AIA® Document G710™ – 2017

Architect's Supplemental Instructions

PROJECT: *(name and address)*
17-13 OSU College of Med. at Hastings
Tahlequah, OK

ASI INFORMATION:
ASI Number: Bid Pack 03-ASI 04
Date: 08/08/19

S2.02
MOMENT FRAME AND BRACED FRAME ELEVATIONS

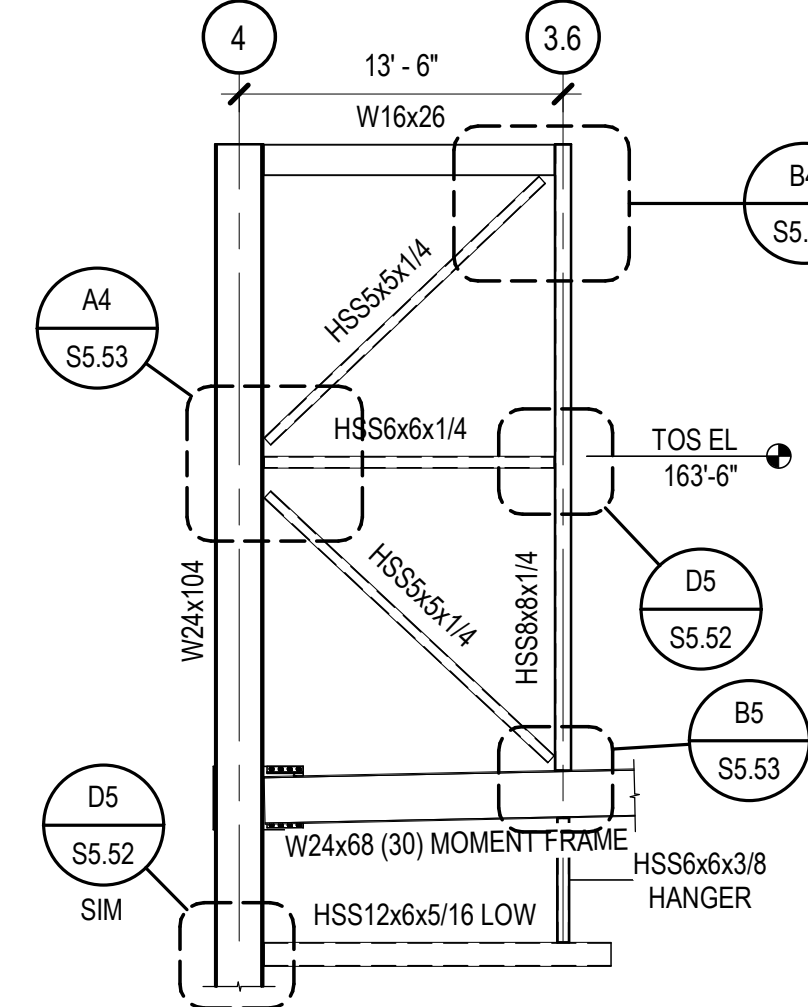
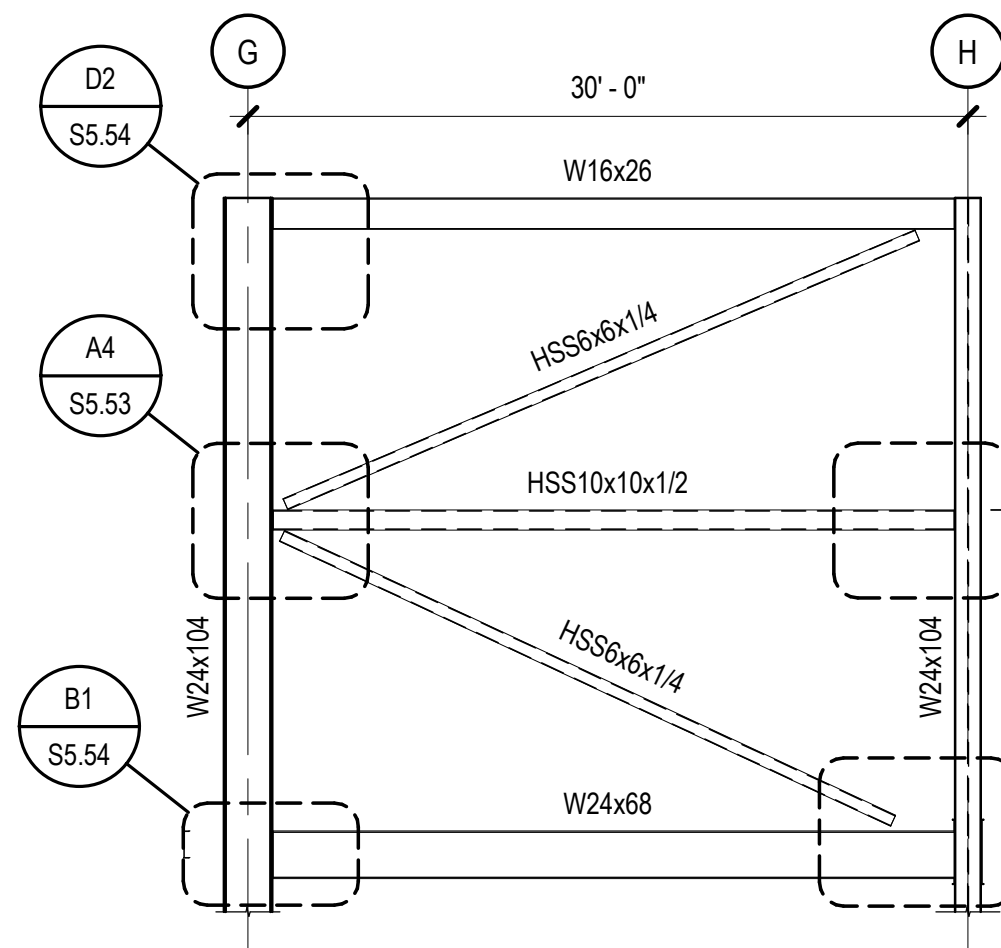
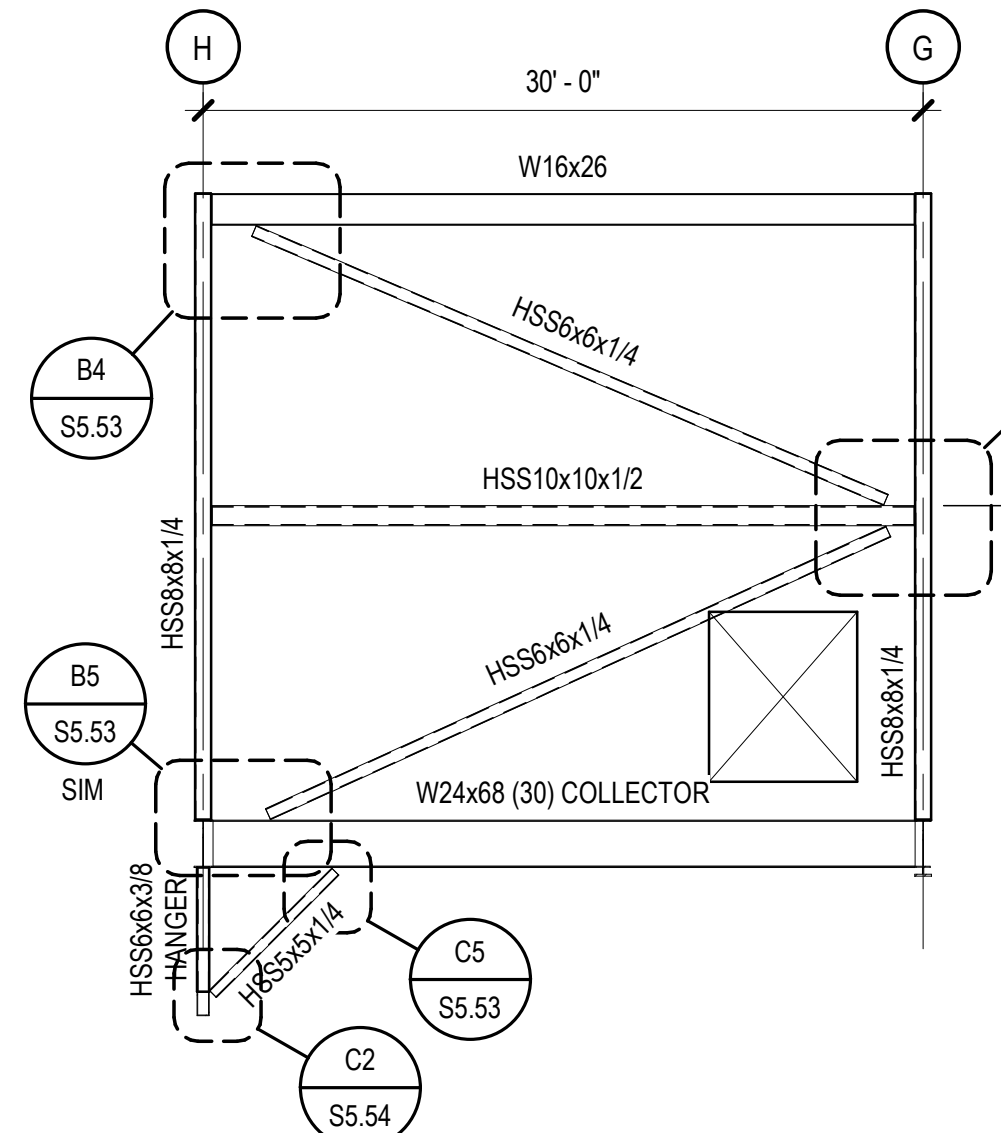
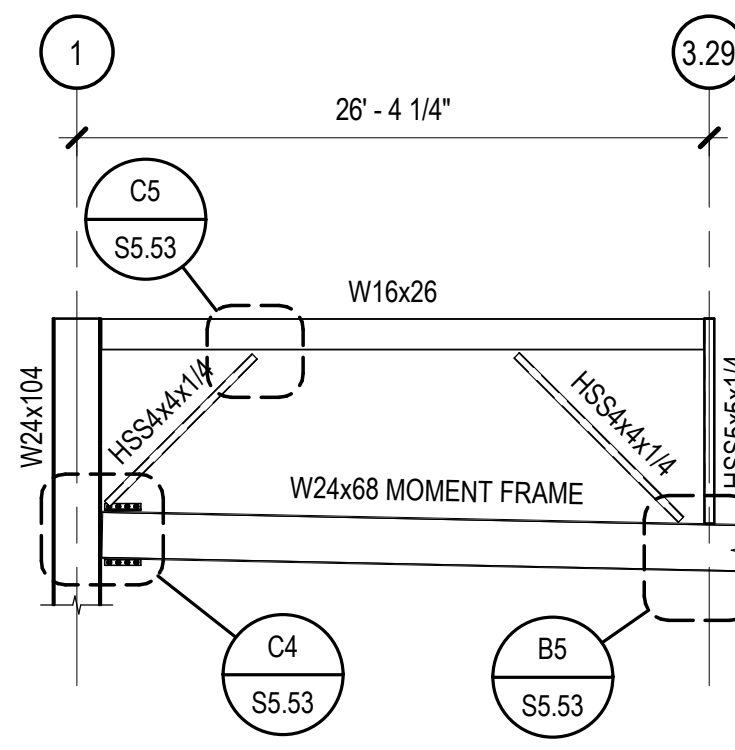
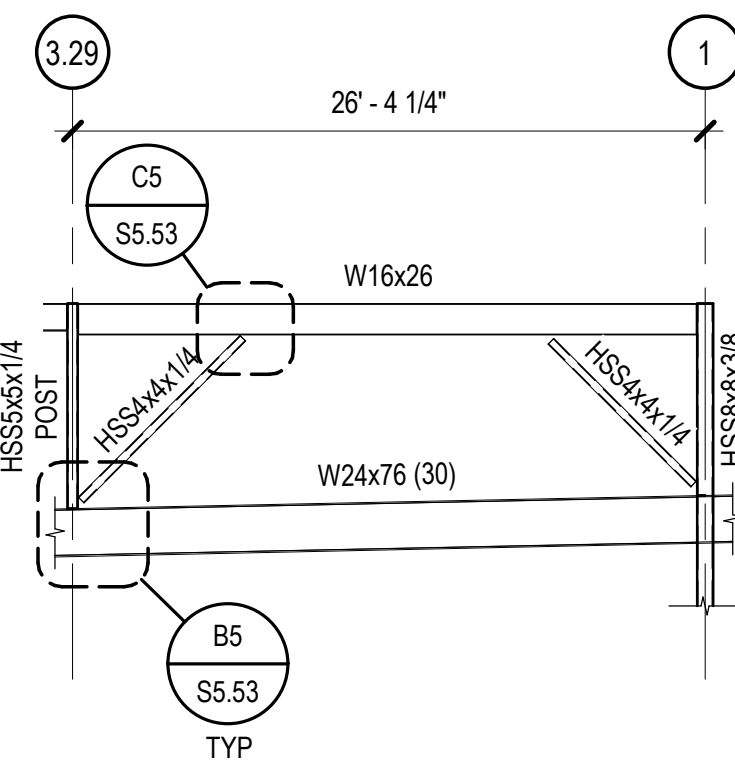
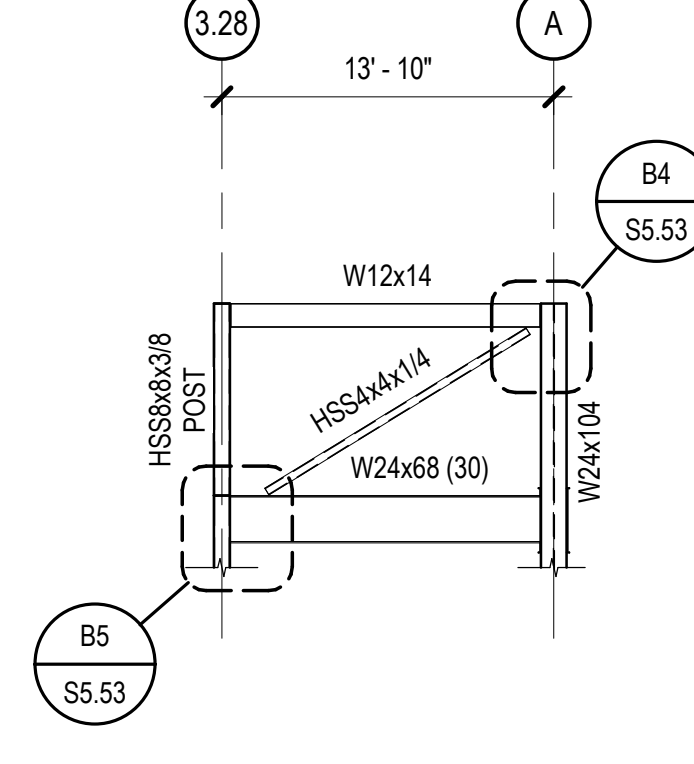
<u>Sheet</u>	<u>Description</u>
S2.02	Braced frame elevations A1, B1, C1, D1, D2, D3, D4, and D5 updated to include additional connection information.
S3.02	Elevation A3 top of steel elevations updated at stair landings.
S4.01	Plan A2 updated to contain revised information for elevated stair landing at the roof level.
S4.01	Plans B3, C3, and D3 updated to contain clarifying hanger connection information.
S4.02	Sheet keynotes 3, 4, and 5 added. Keynotes added on plan.
S4.02	Beam added at landing on plan C4.
S4.02	Stair posts and spread footings removed on plan A4.
S4.02	Stair posts removed from plans A3 and C4.
